Opened Date Permit Number B23004534

Building/Residential/Misc/Porch

SFD/ CONSTRUCT 24' X 9' OPEN PORCH

B23004534_3640 Woodbine Road

PERMIT

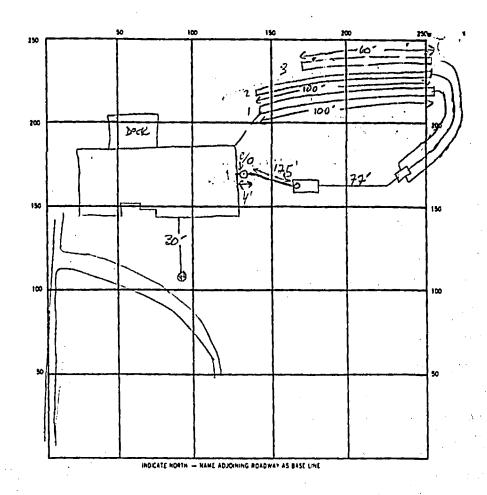
Please update the site plan for B23004534 (3640 Woodbine Road) to include the existing well & septic system components. Please note, there are well and septic setback distance requirements (see attached). Also, you will find a copy of the septic record to assist you with this revision.

I spoke to my supervisor Zack Silvast, and he stated that he was okay with the distance of 21 feet between the existing well and proposed porch on footers/concrete slab. With that said, please revise the site plan showing the existing well and septic system components and include the distance on the plan. Please submit a copy of the revision to Department of Inspections License and Permits (DILP). You may also send to me a copy. If you get it done today before 330, please let me know. Otherwise, you may reach out to my supervisor next Wednesday for further assistance. His email is rsilvast@howardcountymd.gov
